City of Santa Fe

REGULAR MEETING OF THE PLANNING COMMISSION OCTOBER 21, 2021 AT 6:00 PM MEETING VIRTUALLY

1. **Case #2021-4219. Monte Sereno Master Plan Amendment.** Al Lilly, Agent, for 21 Club Holdings LLC, Owner, requests Master Plan Amendment to include infrastructure and design elements for the Hotel Use. The Property is approximately 34.96 acres and zoned PRRC (Planned Residential Resort Community), located West of Highway 285, North of Tano Road at 4000 Monte Sereno Drive, and is within the Monte Sereno Development. (Dan Esquibel, Case Manager, daesquibel@santafenm.gov,505-955-6587)

2. **Case #2021-3800. Monte Sereno Development Plan.** Al Lilly, Agent, for 21 Club Holdings LLC, Owner, requests development plan approval to construct 170,000 square feet of new construction for hotel use. The Property is approximately 34.96 acres and zoned PRRC, located West of Highway 285, North of Tano Road at 4000 Monte Sereno Drive, and is within the Monte Sereno Development. (Dan Esquibel, Case Manager, daesquibel@santafenm.gov,505-955-6587)

GRADING AND DRAINAGE PLAN

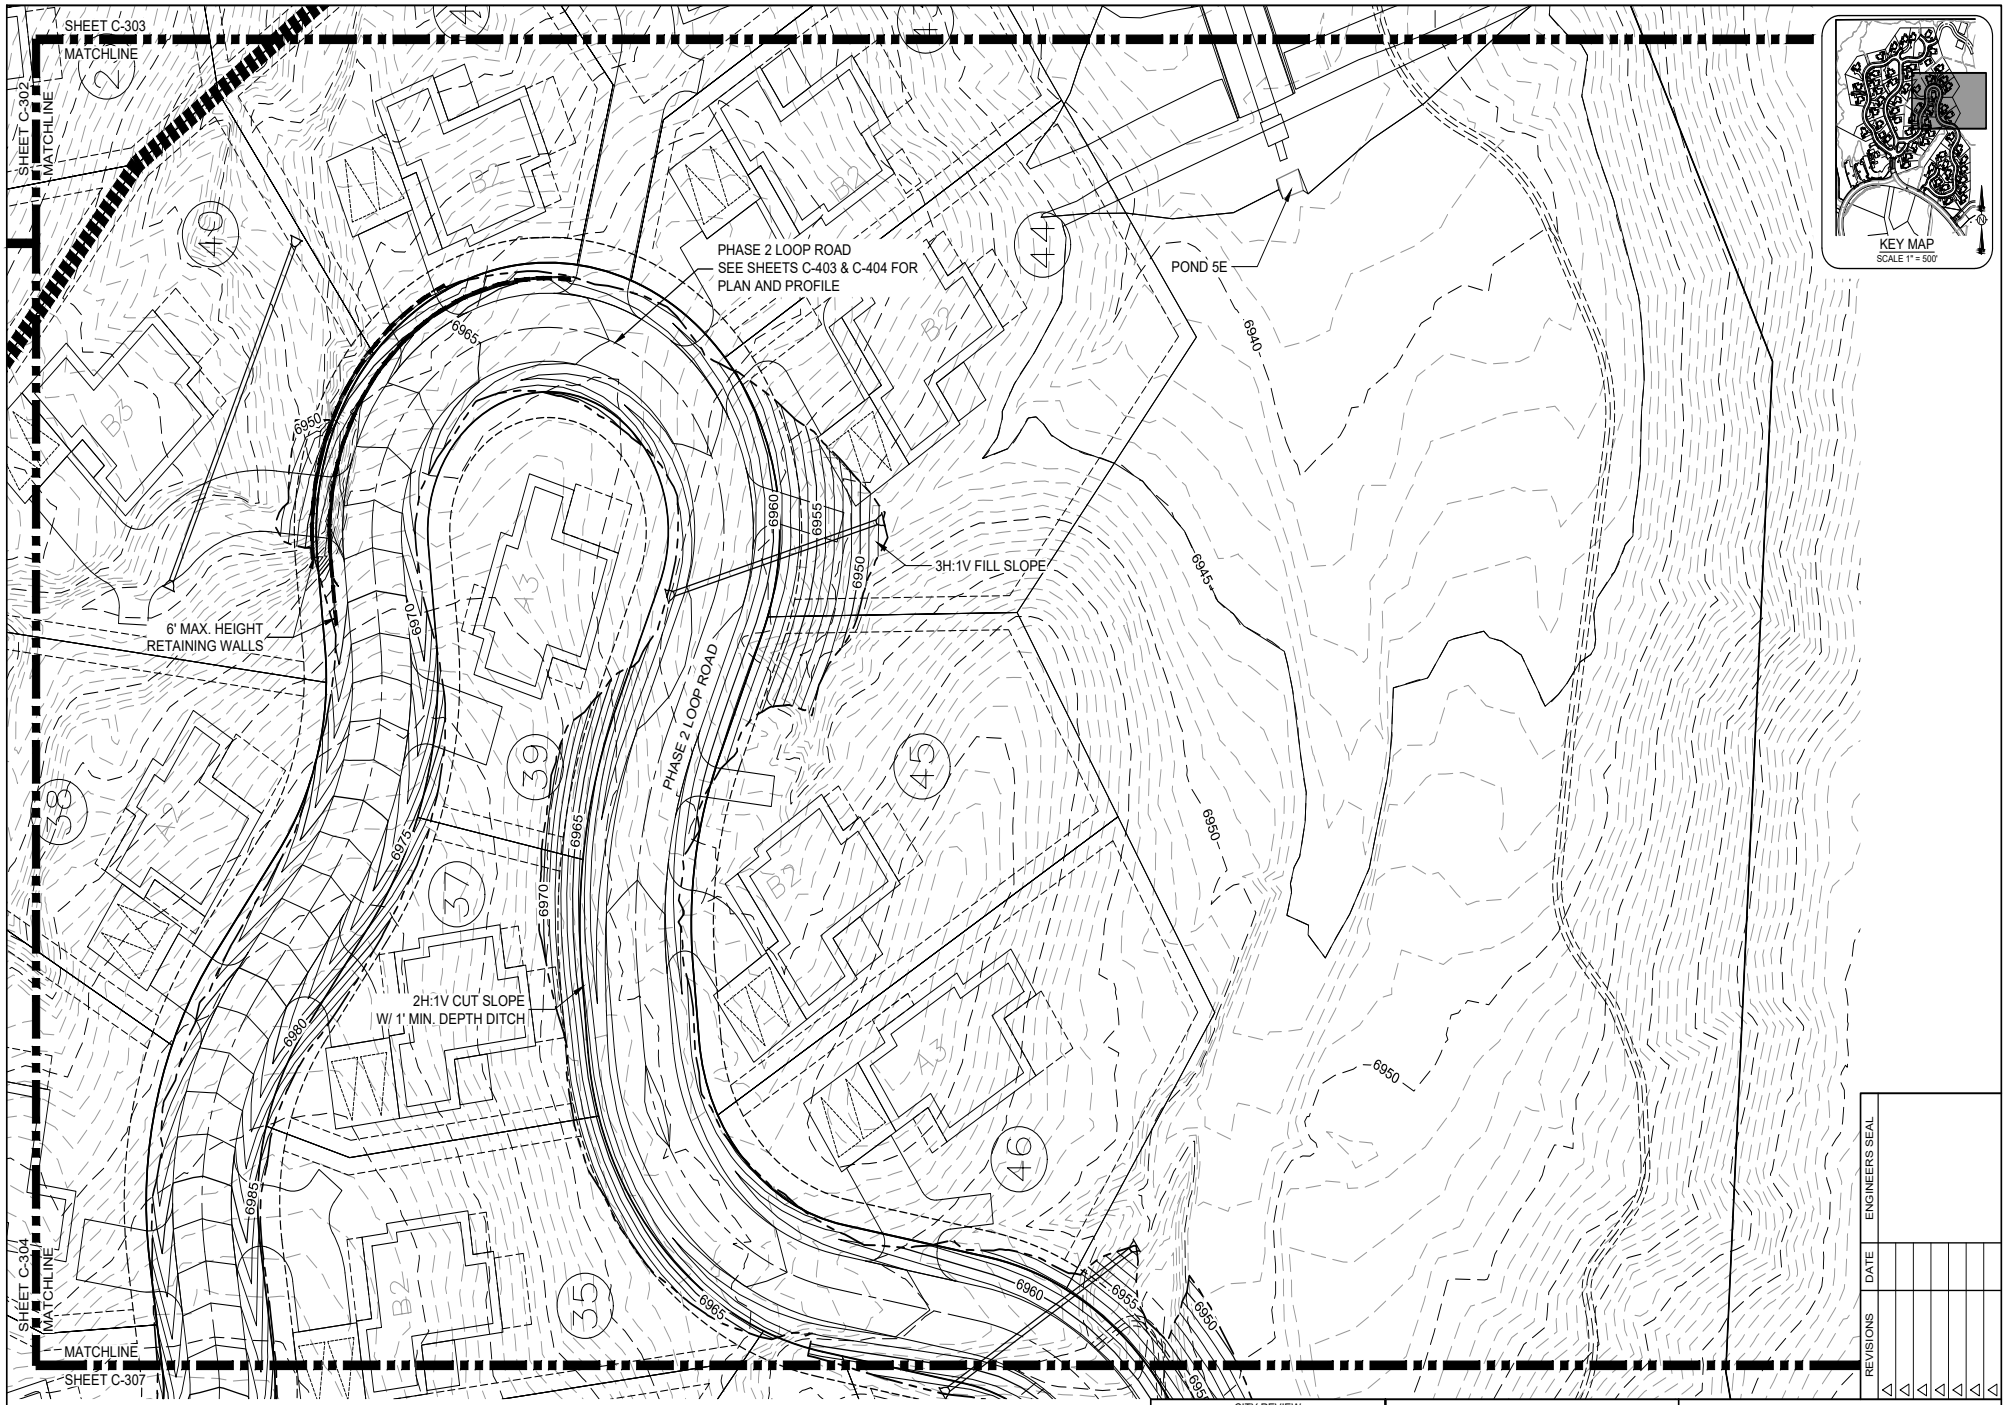
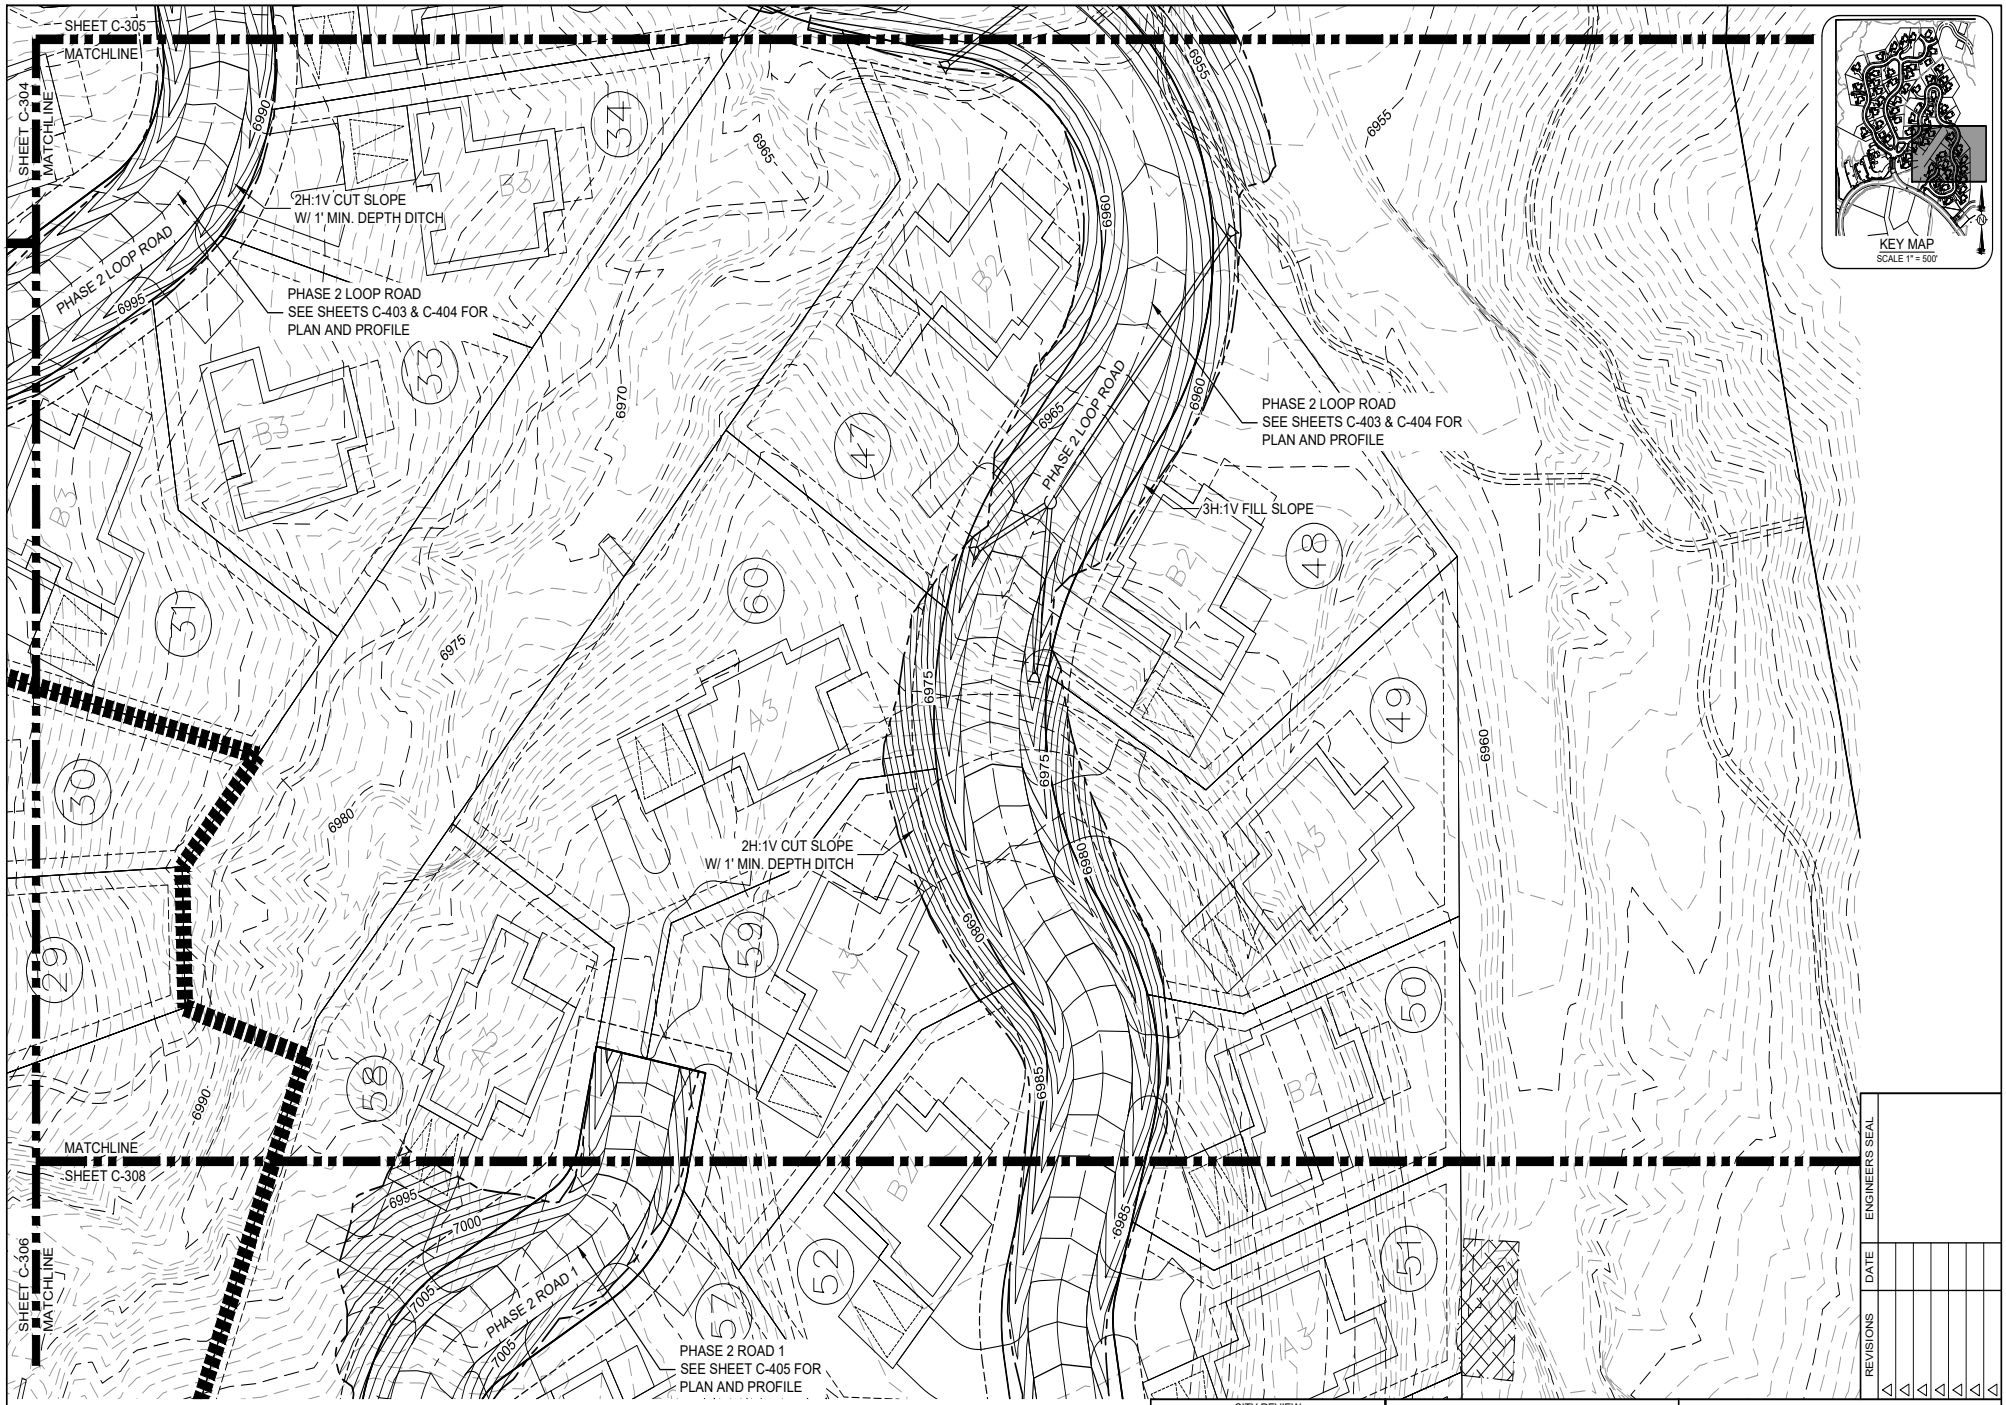
11. Sheet C-301. Label proposed curb and gutter, storm sewer manholes and culverts. Provide detail/section of each pond.
12. Sheet C-302 through sheet C-308. Label existing contour elevations, storm sewer manholes and CMP's. Indicate grading limits and location of utility easement.
